**BLYTHER SOLAR POWER PROJECT (09-AFC-6)**  
**CEC STAFF DATA REQUESTS 30 – 50**

**Technical Area: Alternatives (AFC Section 4.0)**

**Response Date: January 6, 2010**

**Figure DR-ALT-42-2  
Earlier Project Configuration  
Using Only BLM Land**

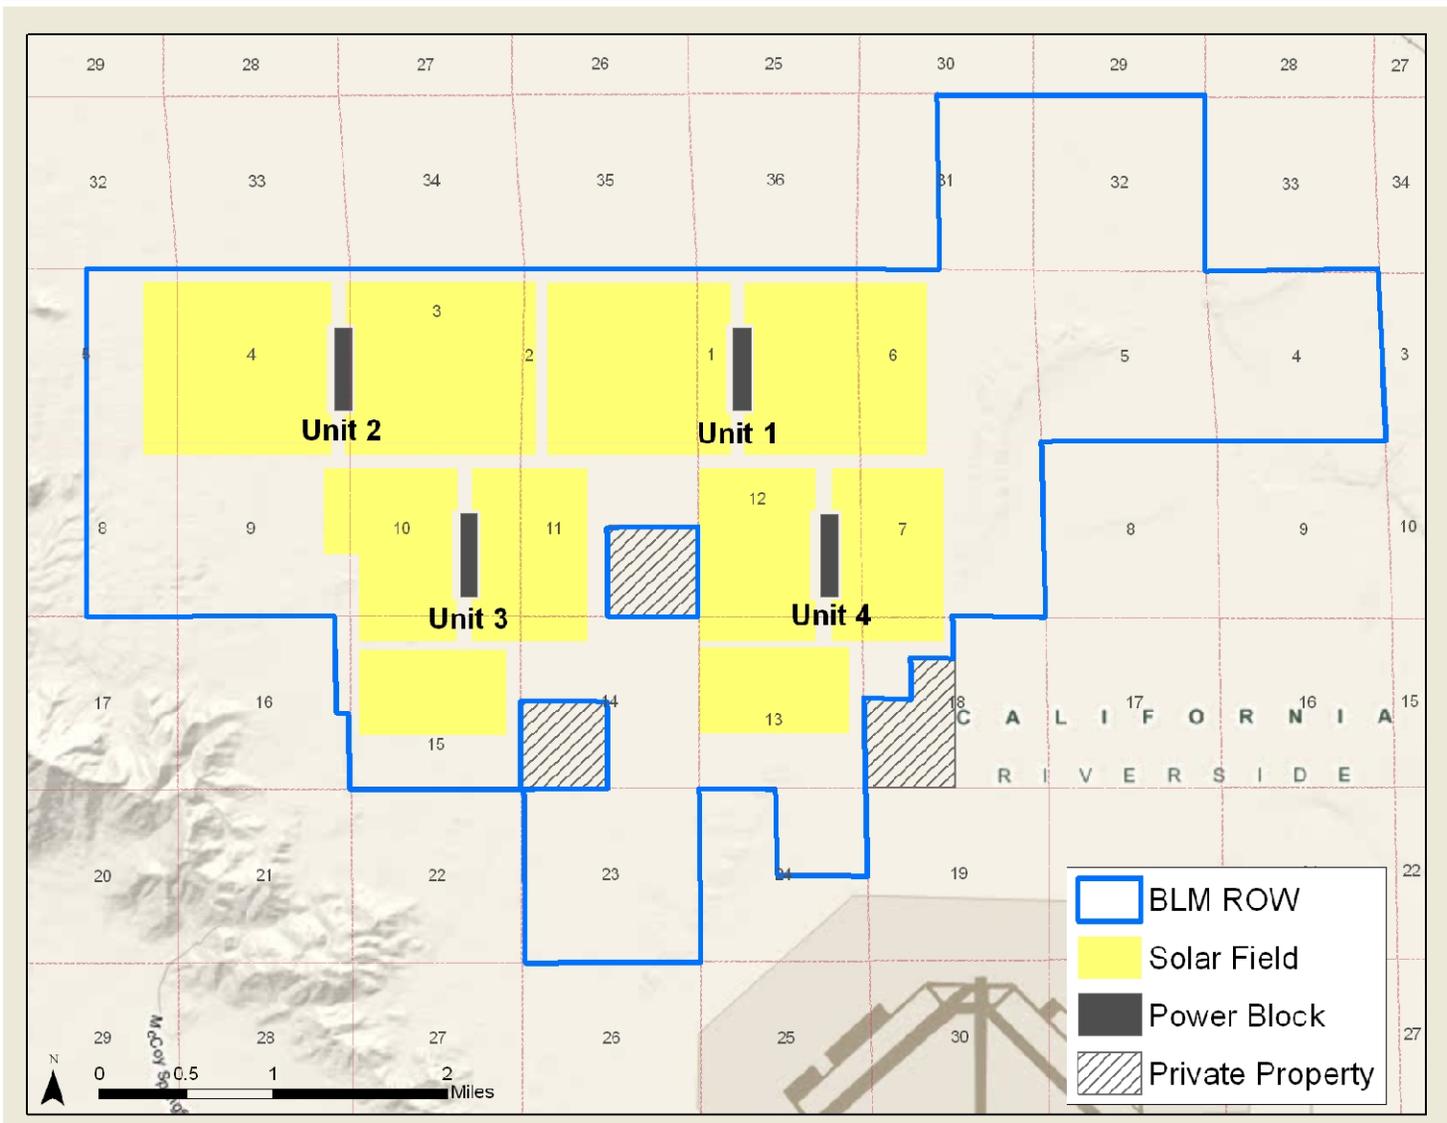
Please provide detailed information regarding any alternative configurations/engineering considered but rejected by the applicant. Please include details regarding the engineering constraints to each alternative configuration.

In an earlier configuration of the Project, the solar fields were designed to utilize three of the private parcels in and around the Project ROW (see Figure DR-ALT-42-1). Due to difficulties in acquiring the private parcels, the Applicant created a layout used in the BLM ROW application that included only BLM land (see Figure DR-ALT-42-2). In addition, in June 2009, the Applicant decreased the ROW size for BSPP by relinquishing three and a half sections in the northeast portion of the ROW. In earlier site layouts, the northeast area was planned for solar energy generation. This area, partly in the McCoy Wash, was relinquished for environmental stewardship reasons to minimize the Project’s impact on biological and cultural resources (see Figure DR-ALT-42-3).
